EPC STORMWATER REVIEW COMMENTS IN ORANGE BOXES WITH BLACK TEXT

VOLLMER ROAD (BARBARICK) - INTERIM CONDITION

GRADING AND EROSION CONTROL PLANS AUGUST 2022

VOLLMER ROAD (BARBARICK)
 -INTERIM CONDITION
 INITIAL/INTERIM GESC

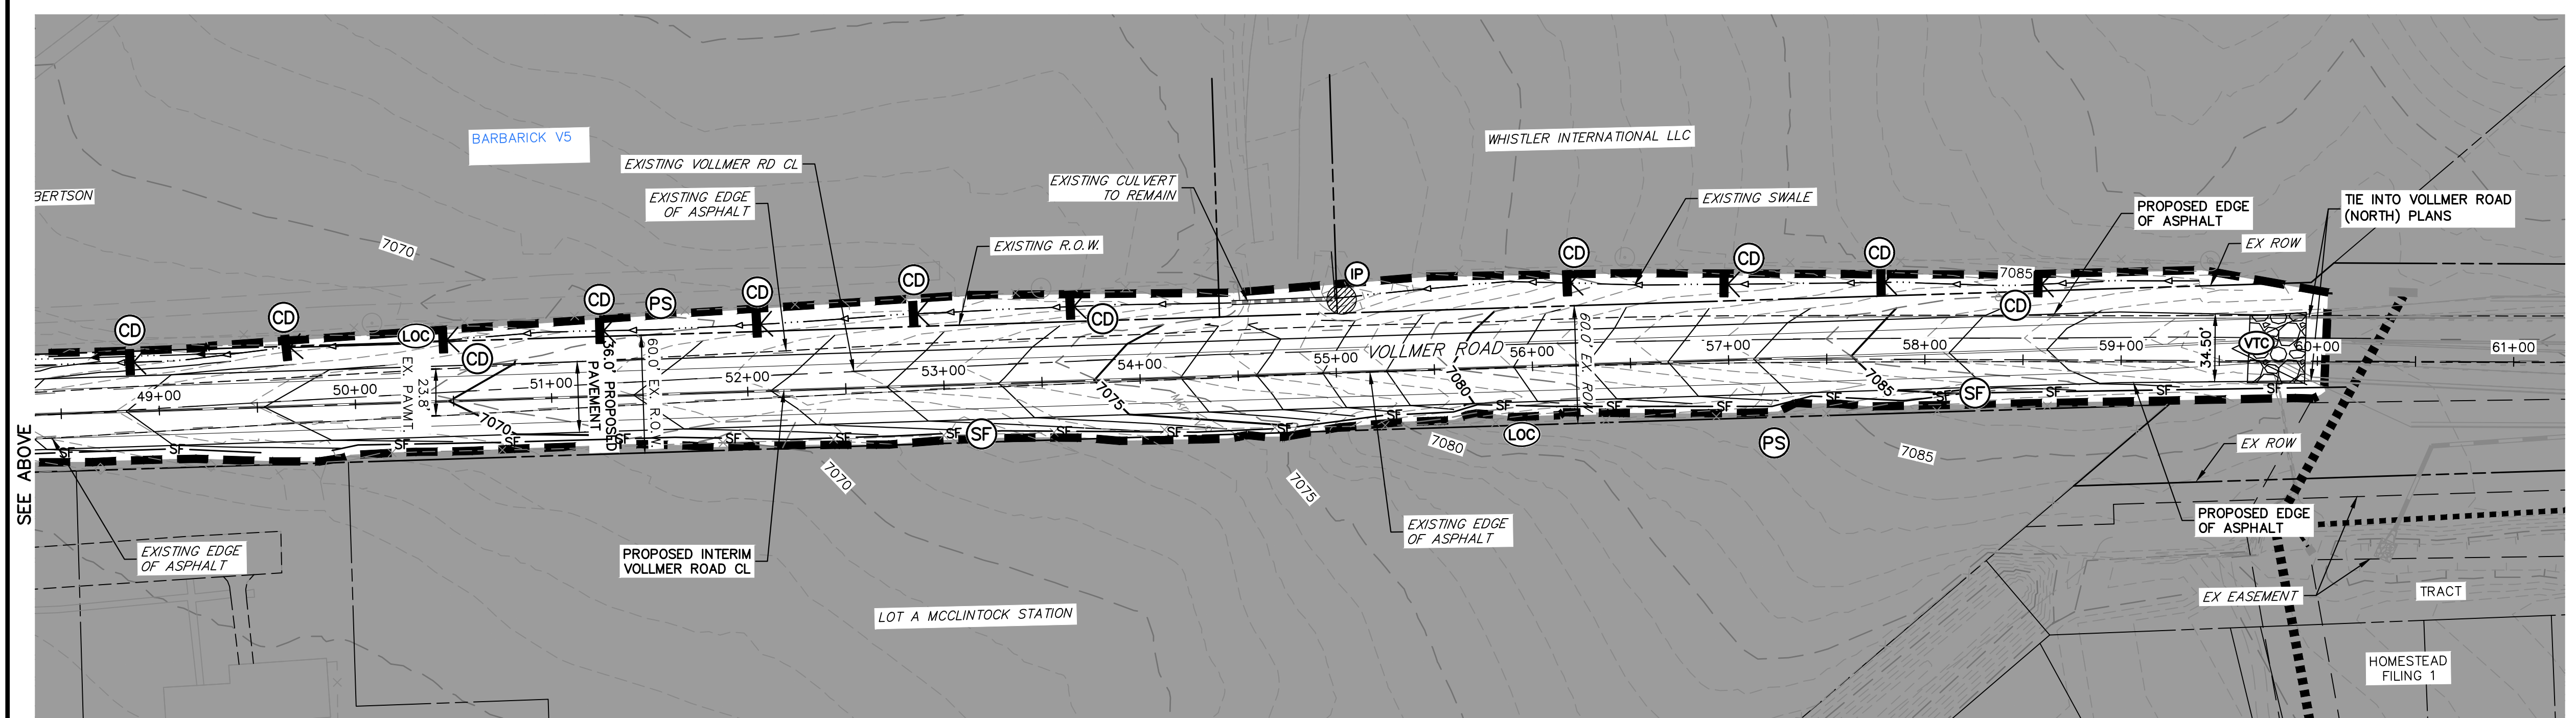
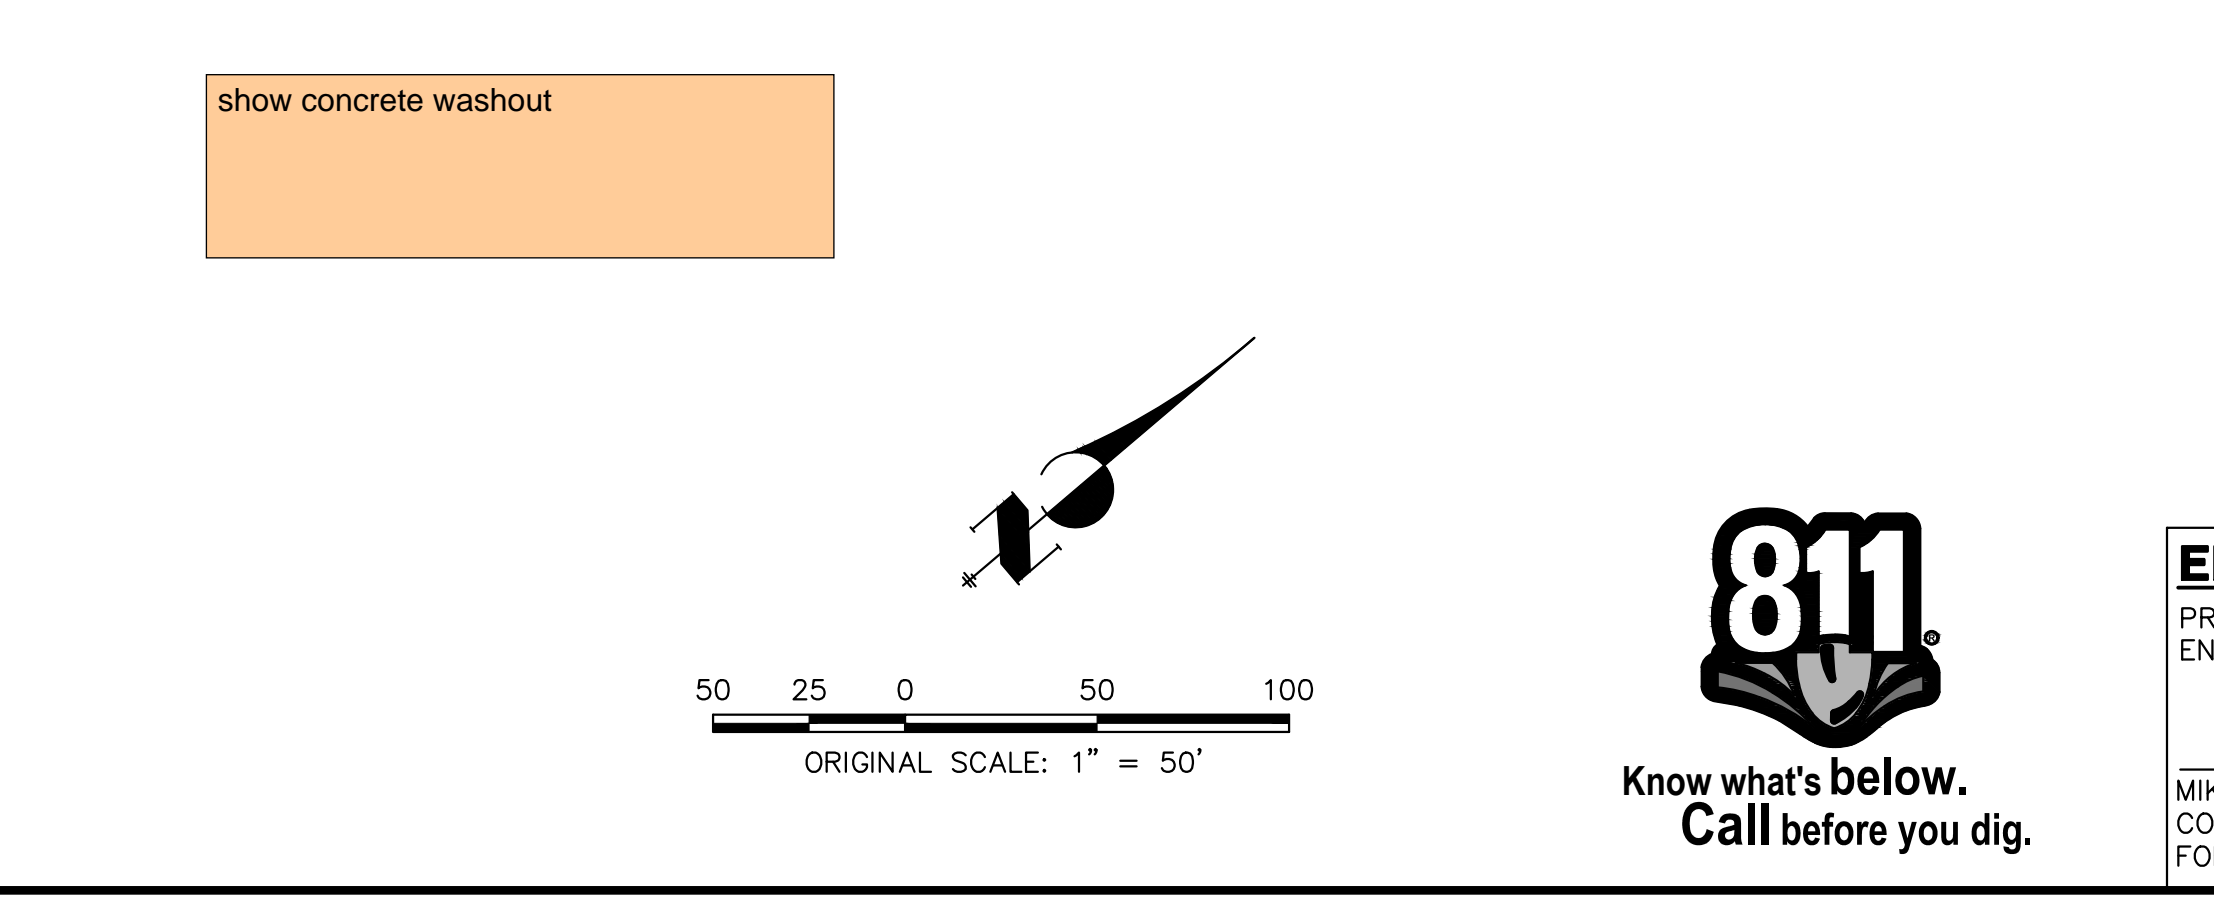
SWMP stated a different percent. Verify and update so both match.
